SERVICE BULLETIN

BT21-004

2012-2015 TITAN; HIGH-MOUNTED STOP LAMP SERVICE PART

APPLIED VEHICLES: 2012-2015 Titan (A60)

Figure 1

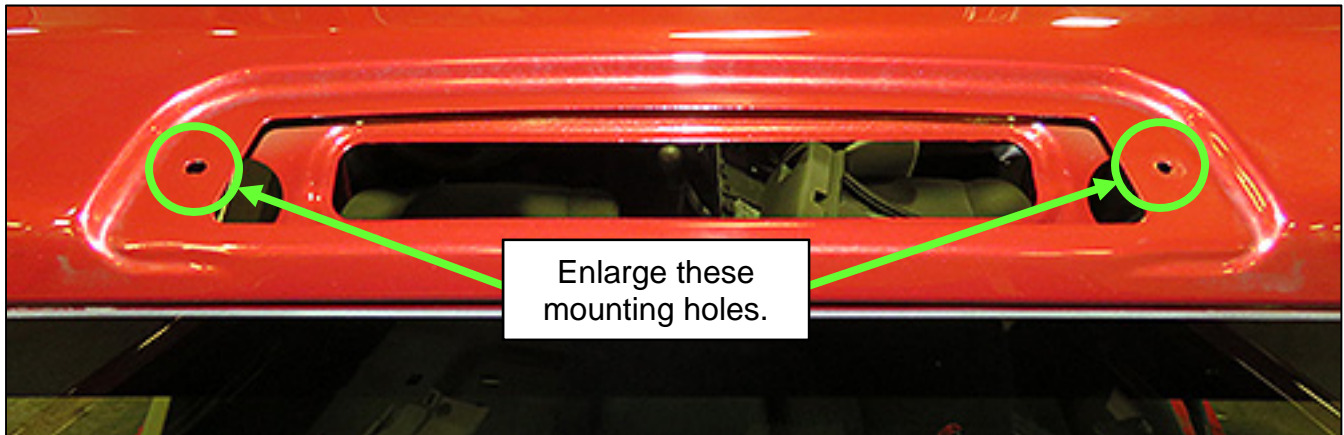
The mounting stud diameter for the high-mounted stop lamp service part has changed from 5 mm to 6 mm.

If, for any reason, the high-mounted stop lamp needs to be replaced, the mounting hole will need to be enlarged to 6.5 mm ($\frac{1}{4}$ inch) as follows:

1. Remove the high-mounted stop lamp.
 - For high-mounted stop lamp removal, refer to the Electronic Service Manual: Section **DRIVER CONTROLS > EXL – Exterior Lighting System > HIGH-MOUNTED STOP LAMP > Removal and Installation > HIGH-MOUNTED STOP LAMP**.
2. Enlarge the high-mounted stop lamp's mounting holes (see Figure 1 on page 2) using a 6.5 mm ($\frac{1}{4}$ inch) drill bit.

NOTICE To avoid damage to the vehicle, apply light pressure to the drill while drilling. Excessive force may cause the drill bit to penetrate too far and damage the headliner.
3. Apply touch-up paint to the mounting holes to protect the bare metal.
4. Install the new high-mounted stop lamp using M6 mounting nuts. Refer to the **PARTS INFORMATION** on page 2.
